**ITEM:** PLAN COMMISSION FILE NO. 07-04 – Request for approval of a proposed Special Use to authorize a two-story banking facility with a Drive-Through window and Variations.

**DATE:** August 20, 2004

## PLANNING &amp; COMMUNITY DEVELOPMENT / STAFF DEVELOPMENT TEAM REPORT

**TO:** Joseph P. Skach, AIA, AICP, Director of Planning & Community Development  
**FROM:** David H. Barber, P.E., Director of Public Works *DHB*  
**BY:** Michael D. Millette, P.E., Asst. Director of Public Works – Engineering *M.D.M.*  
 Jonathan C. Hall, P.E., Development Engineering Manager *JCH*  
**DATE:** June 14, 2004  
**RE:** Planning / Zoning Request  
 Revised Documents Community Bank  
 Public Works Department **Final Review (3<sup>rd</sup>)**

**SITE UTILITY PLAN**  
 COMMUNITY BANK OF DOWNERS GROVE  
 1111 WARREN AVENUE  
 DOWNERS GROVE, ILLINOIS

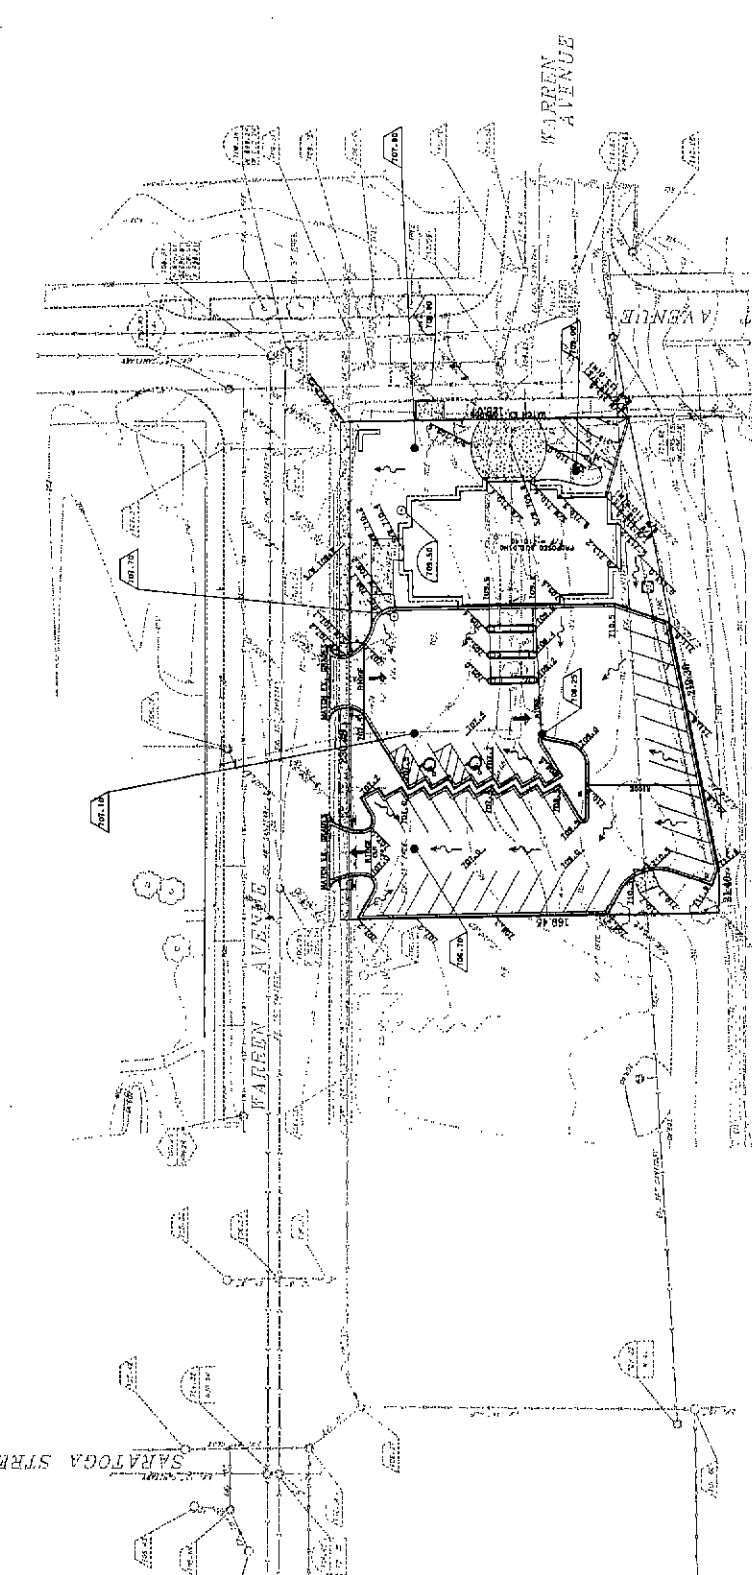
2. Water main located on Warren Avenue is 12" and the water main on Forest Avenue is also a 12". The Utility drawing shows 6" on both streets
3. The 6" pressure tap on Warren is ok. The valve must be a resilient wedge type with stainless steel bolts.
4. The Valve must be in a 72" valve vault due to the size of the water main on Forest Ave.
5. The 2" tap for domestic water to the building can be tapped off the 6" fire line with the B-Box located in the R.O.W.
6. The Existing Building on the lot has an existing water service that must be disconnected at the main on Warren before the building can be demolished.
7. The water main must be a class 52 ductile iron and be poly wrapped.

In addition, in the second paragraph of John Hall's comments, he states that underground chambers will likely be required to provide for the compensatory excavation quantity. If you refer to drawing C5 in the most current submittal, Seton Engineering has already provided a "Stormtrap Structure" that is 45'x 45'x 4' deep in the northern portion of the parking lot that does drain to the existing 48" RCP which runs parallel to Warren Avenue.
